Thermomixer comfort 5355 000.011

Thermomixer R 5355 000.020

(BI Catalog No. 22 67 010-7 / 22 67 015-8)

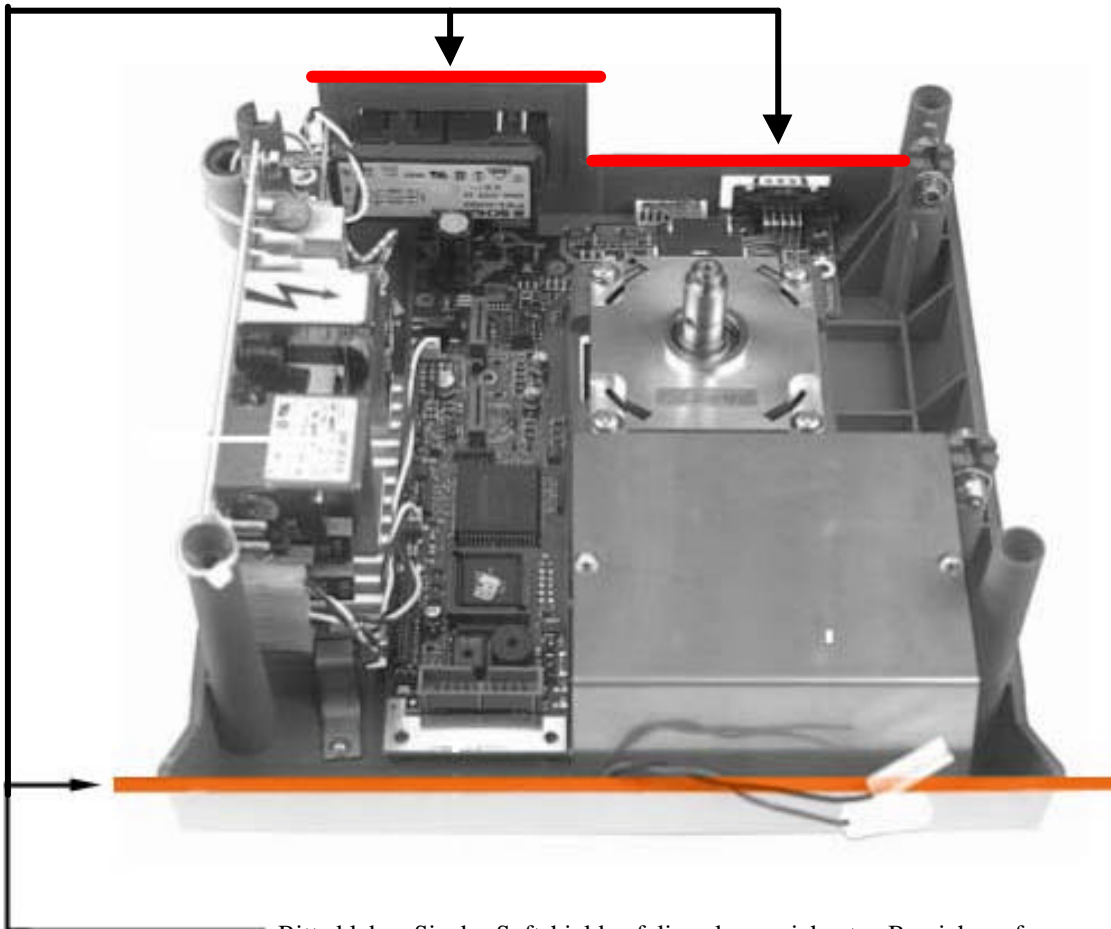
The following error has been observed in the case of a few Thermomixers manufactured prior to the start of 2001: The device switches independently from the set temperature to the upper control temperature of 99°C.

This is caused, under certain operational conditions, by an incomplete electrical discharge of the housing.

This problem has only arisen with some 0.03 % of the devices delivered. We wish to retrofit the affected and other devices on the market prophylactically with the improved static diversion (soft shield).

(Order No. 0011 205.208, soft shield, length = 1 m.) The disassembly of the upper part of the housing is described in the service manual for thermomixer 5355 900.055. The way to glue the soft shield is described on the following page of this PACT.

Bitte kleben Sie das Softshield auf die gekennzeichneten Bereiche auf.
Please glue the soft shield to the marked areas.
